Application for Licence Amendment

Licence Number	L5107/1988/13
Licence Holder	Northern Star (HBJ) Pty Ltd
ACN	30 127 026 519
File Number	DER2015/002027-6
Premises	South Kalgoorlie Operations – Jubilee Gold Mine Legal description – Lot 15 on Plan 58833, Lot 50 on Plan 226299 and Lot 51 on Plan 226303, Feysville, Lot 103 on Plan 40395 Lot 105 on Plan 40396, Karamindie, and mining tenements M26/118, M26/143, M26/204 and M15/456
Date of Report	28 November 2022
Decision	Revised licence granted

Figure 3: Jubilee TSF monitoring bore location

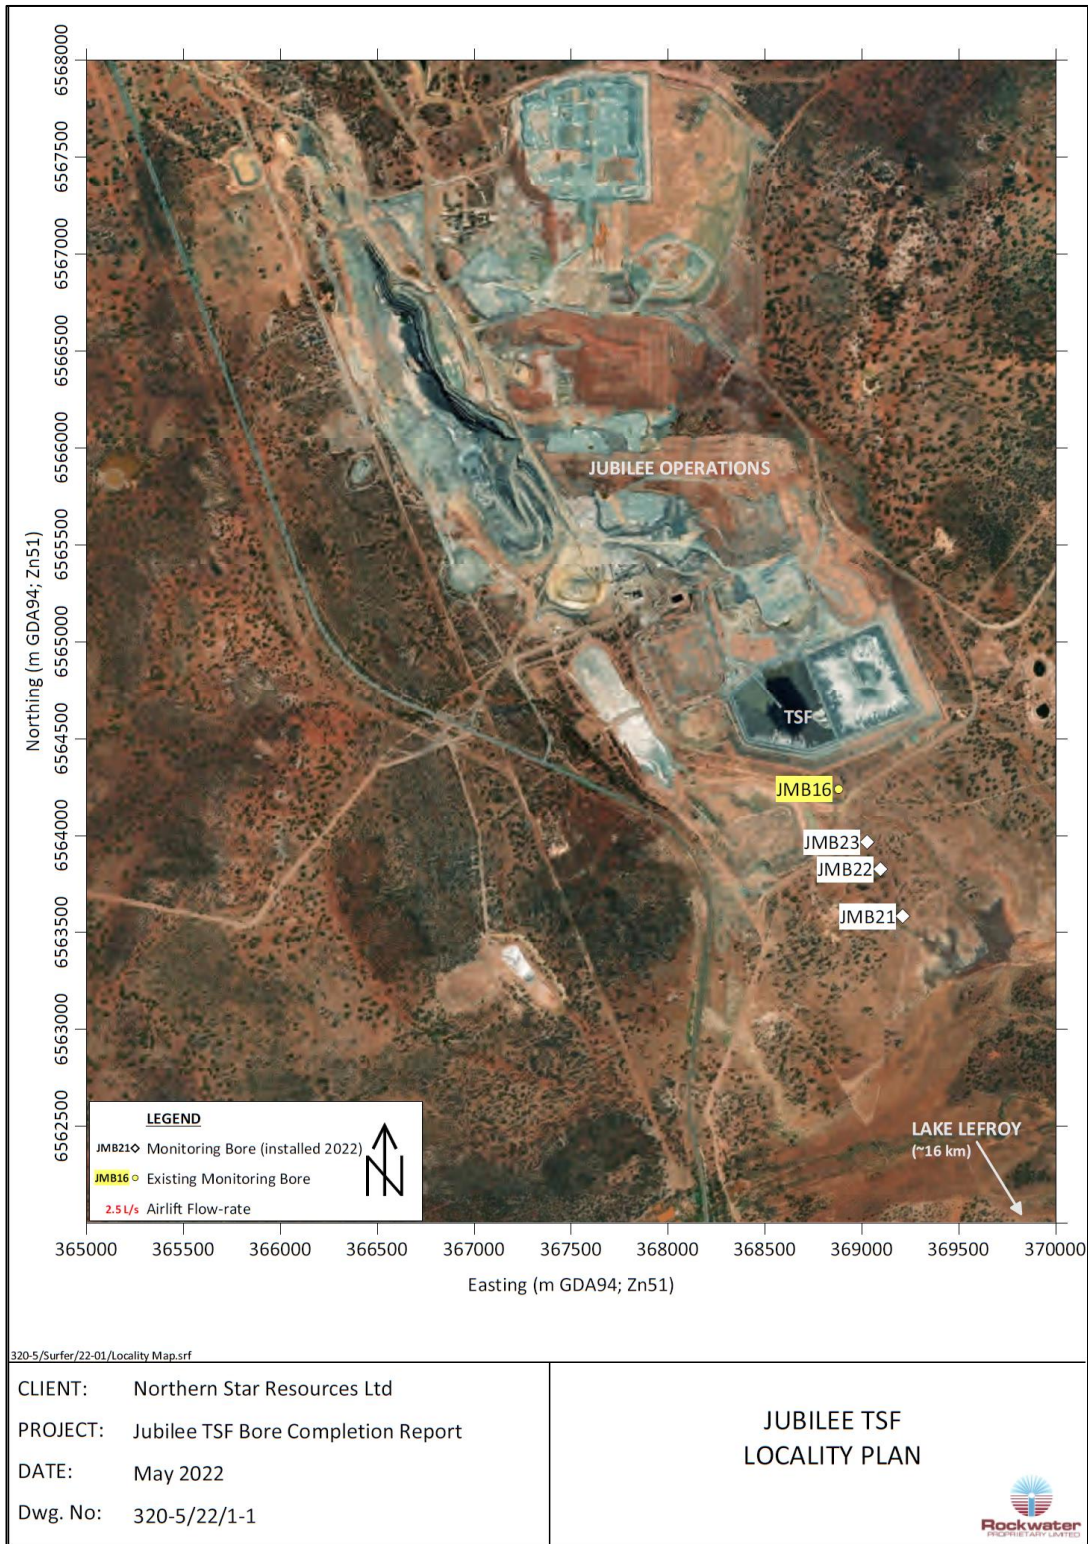
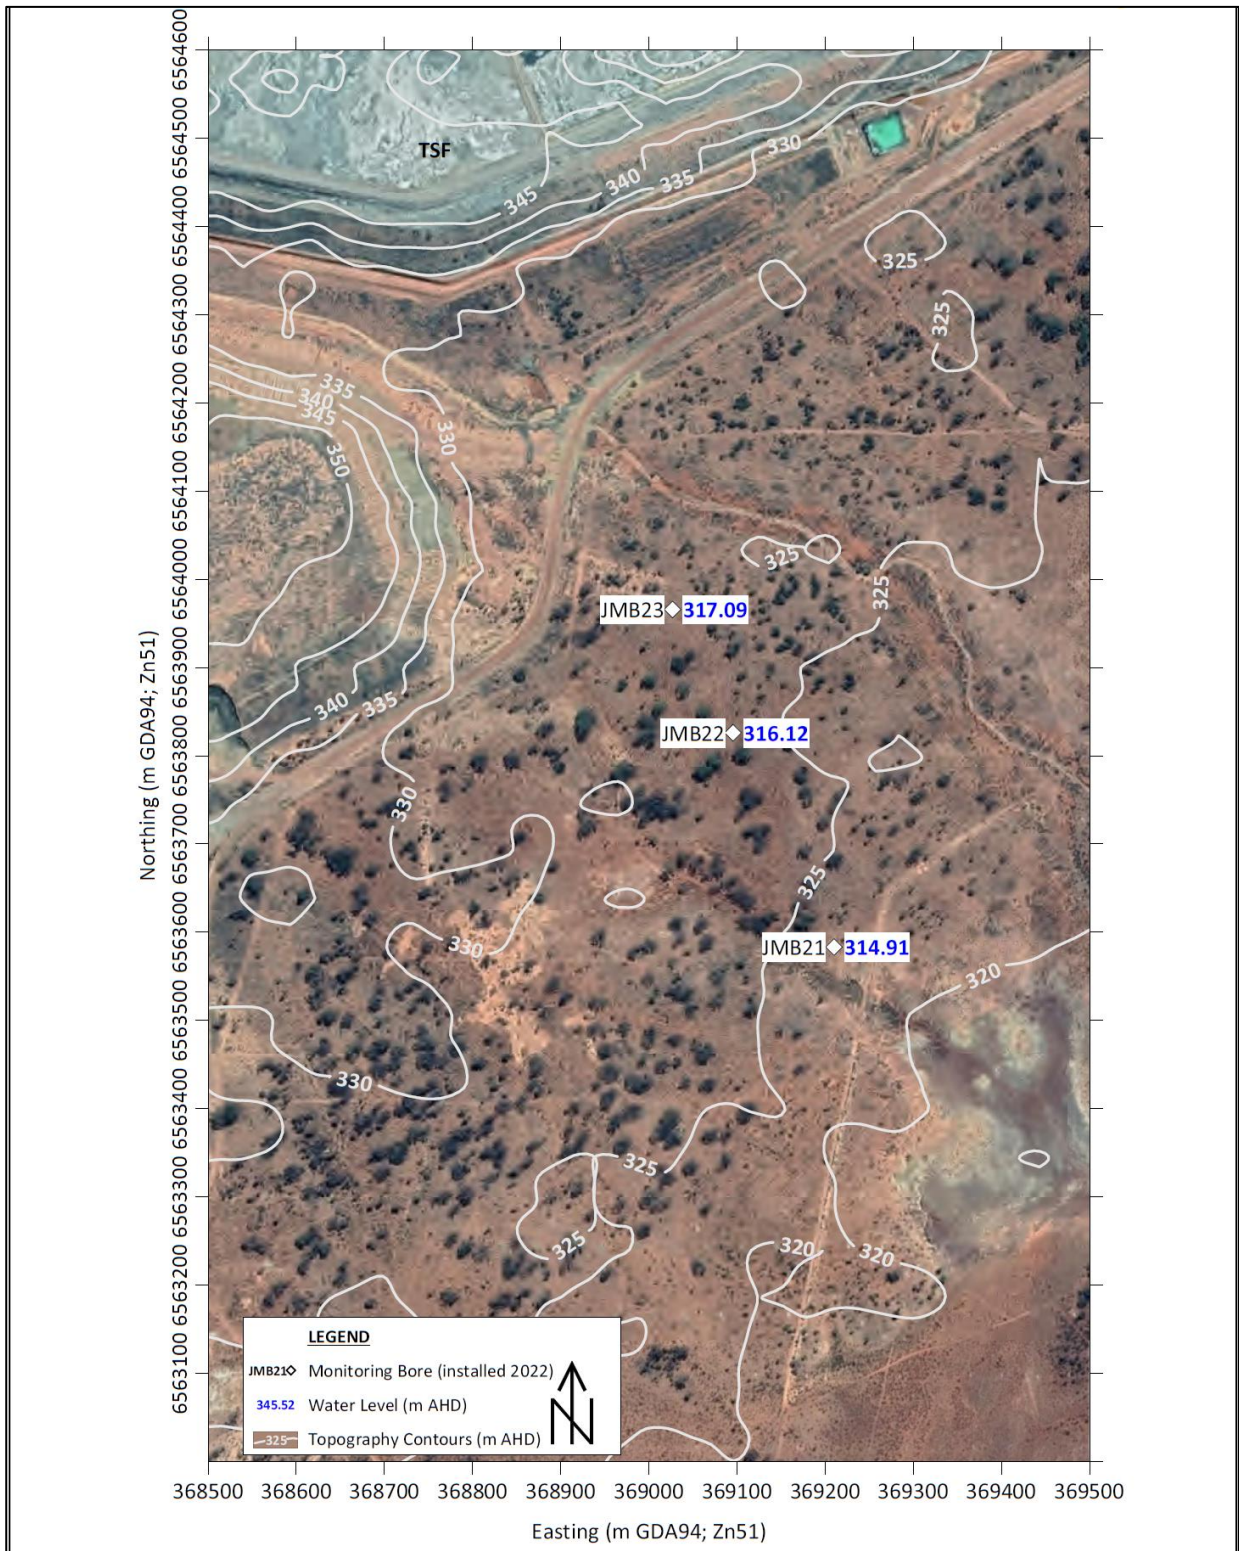
Groundwater levels in the three monitoring bores are presented in Figure 4. Ground water levels are highest in the north-west, JMB23, closer to the TSF (317.09 m AHD). The monitoring bore, JMB21, is 2 m lower than JMB23, which is typical of surficial aquifer regional flow in the area towards Lake Lefroy, located 16 km south/south-east of Jubilee and could indicate seepage from the TSF.

Total cyanide in the three bores ranged from 0.221 to 0.696 mg/L. For both total cyanide and salinity, concentrations are higher in JMB23, which is the closest monitoring bore to the TSF, while the lowest concentrations are recorded in JMB21. It may be evidence of seepage from the TSF.
